Plan Commission

Agenda

Monday, February 26, 2018	7:00 PM	De Pere City Hall Council Chambers
----------------------------------	----------------	---

- ITEM 6:** Recommendation regarding a Site Plan for a new business and parking area called McDonald's at 1022 Main Avenue (Parcel WD-708-X-1-2). Submitted by Landform Professional Services LLC.

SHEET NO.
C2.4

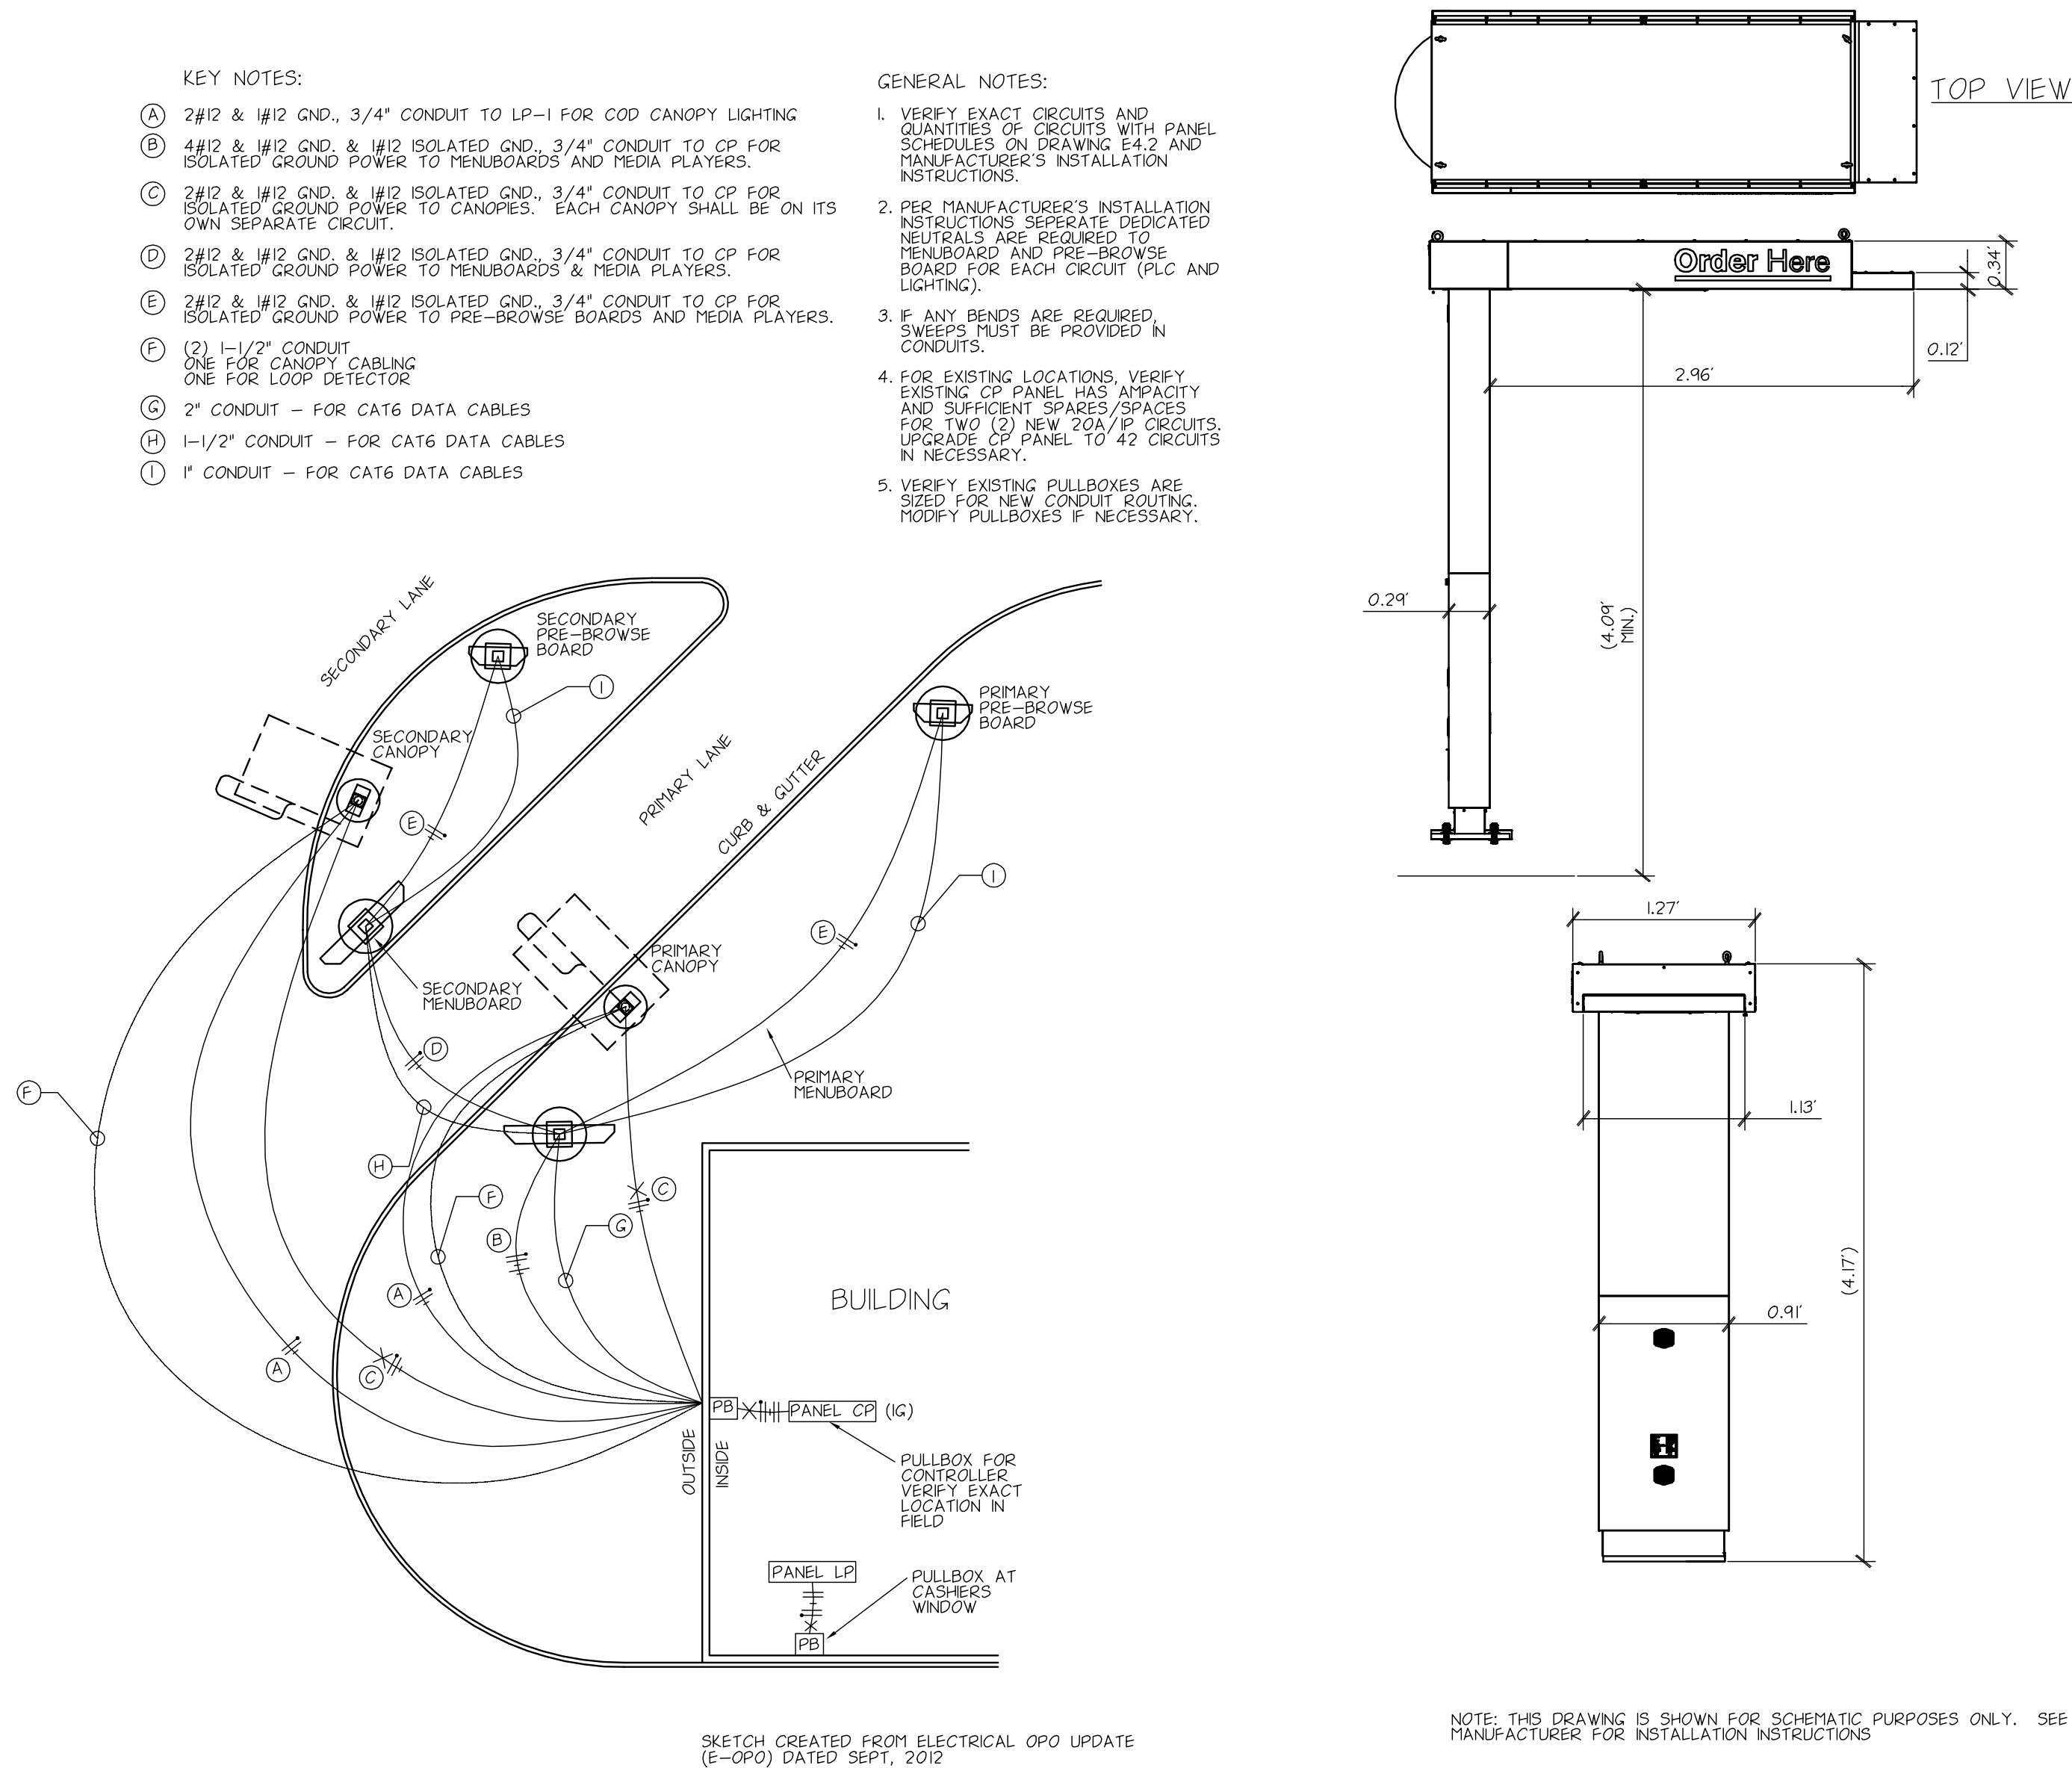
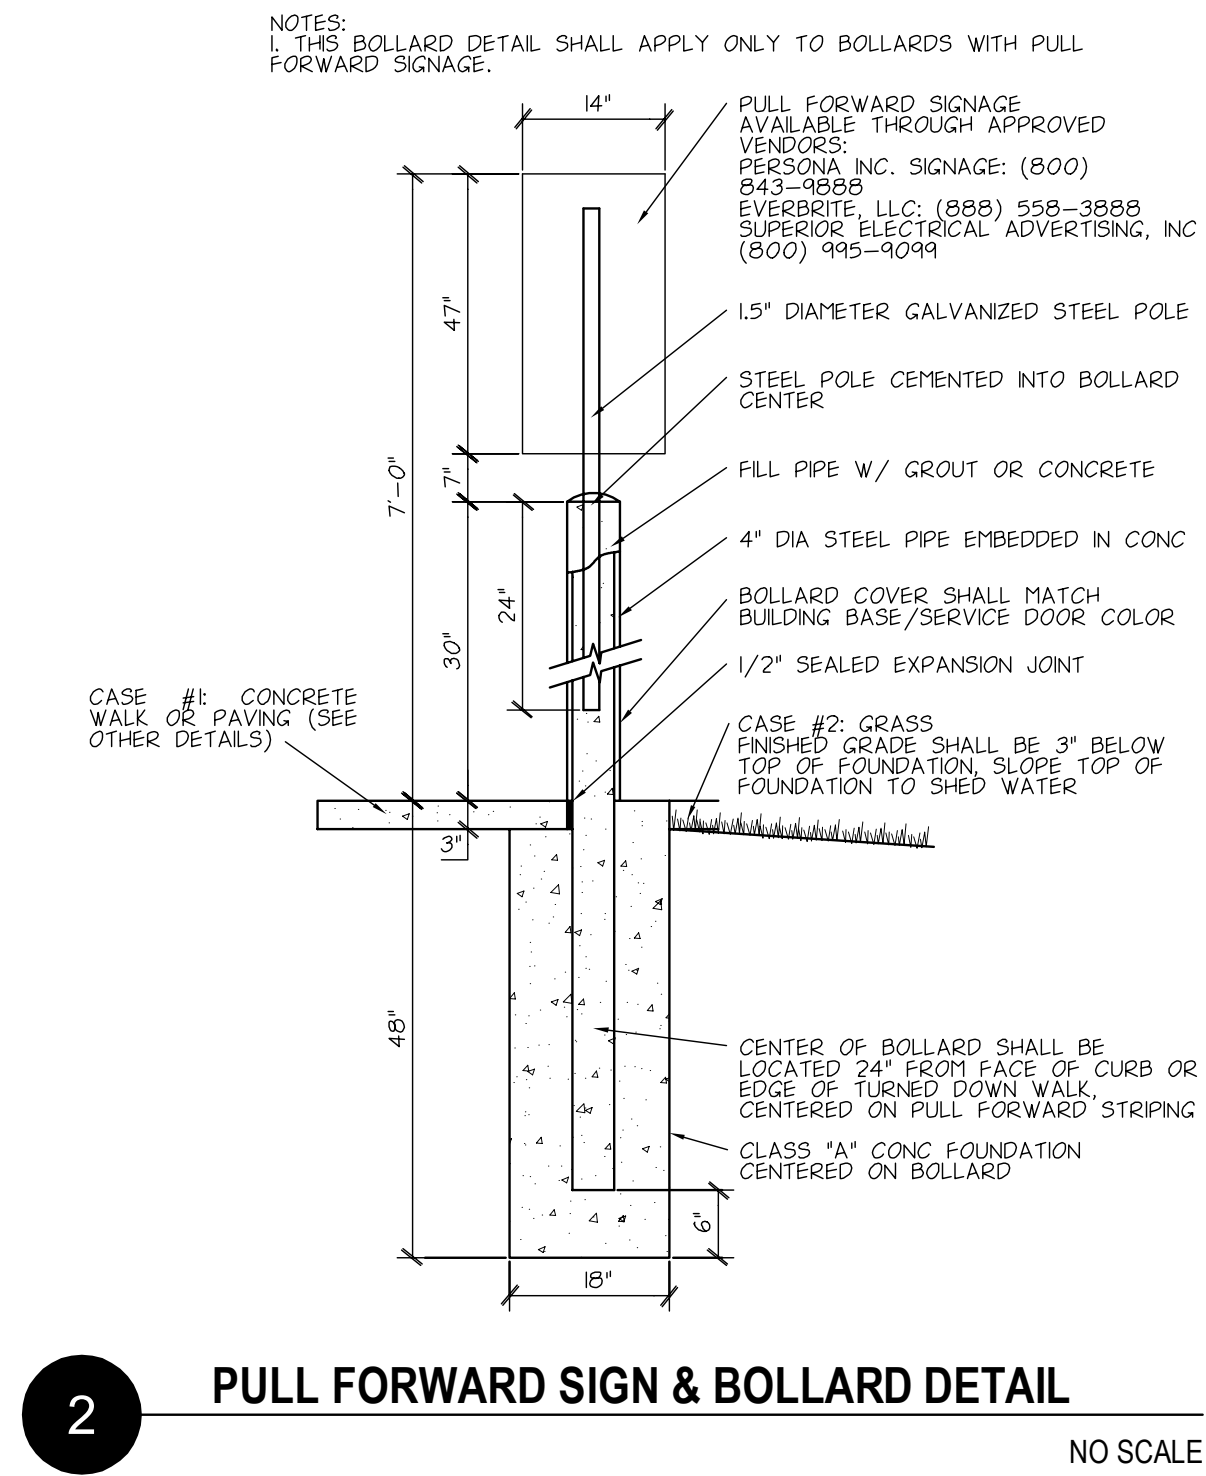
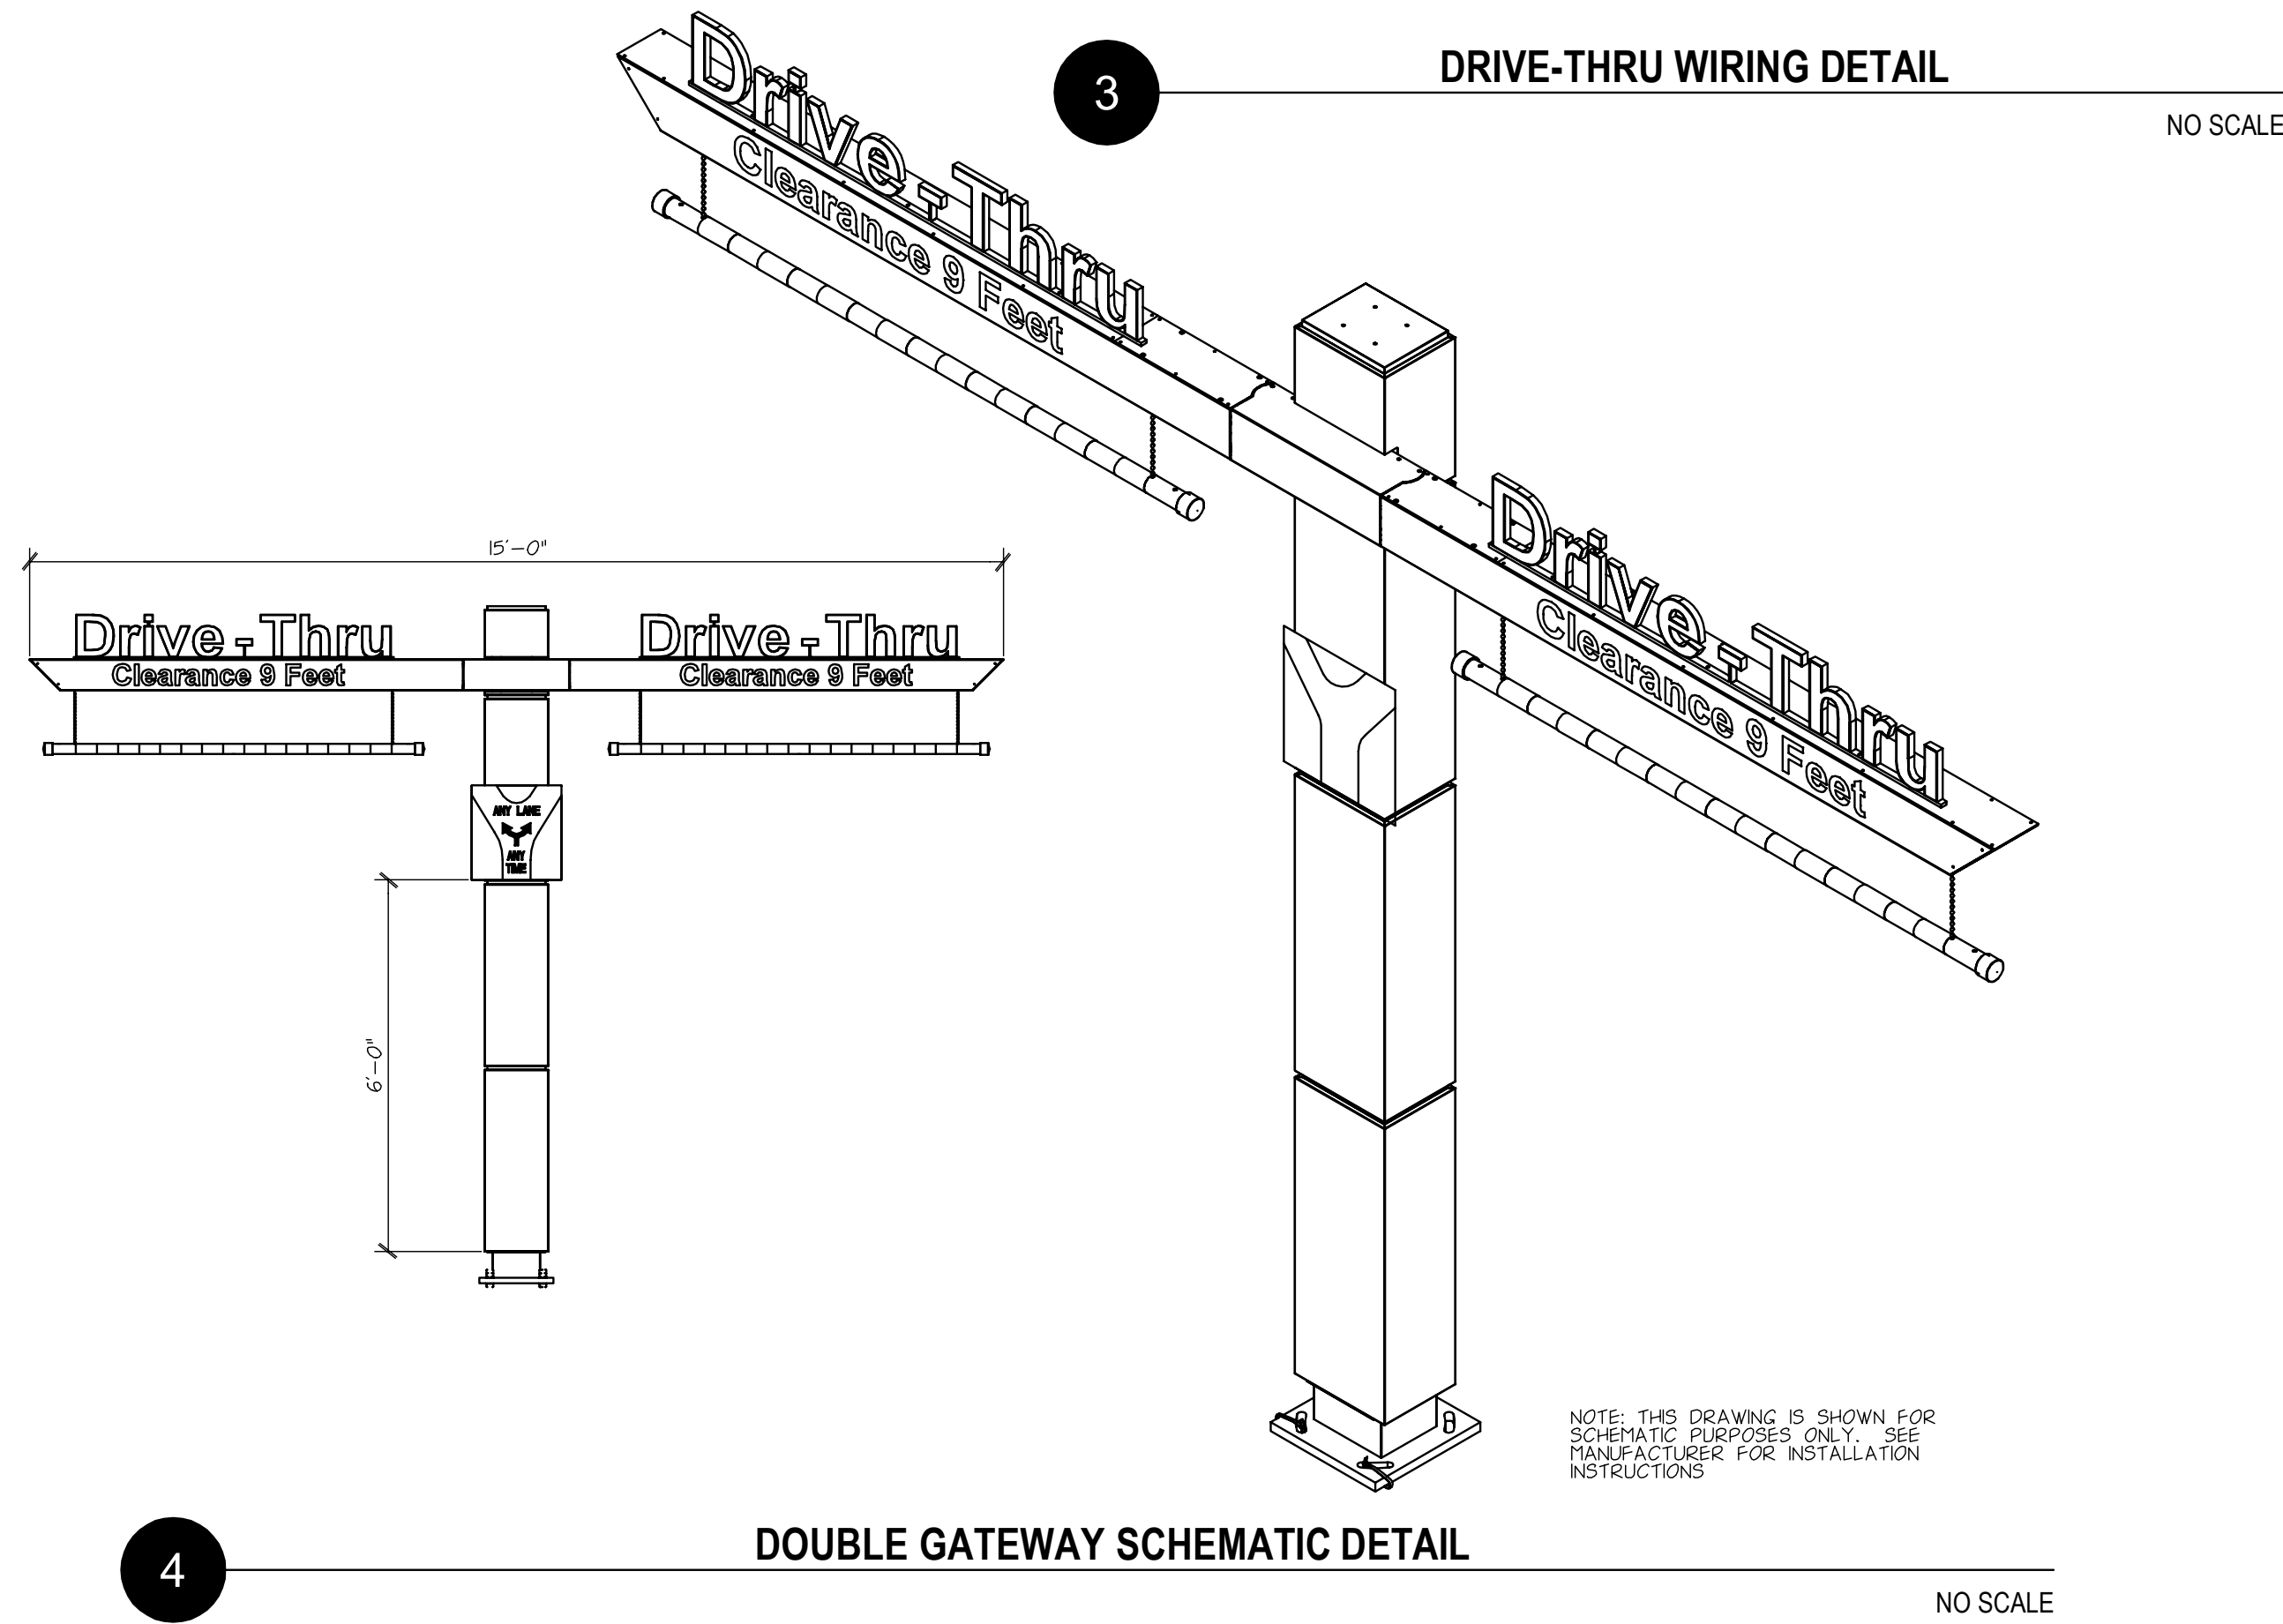
9. *On sheet C2.3: The titles for the Drive-Thru Details should end with "RATING" to be consistent with sheet C2.4.*

Revised on sheet C2.3
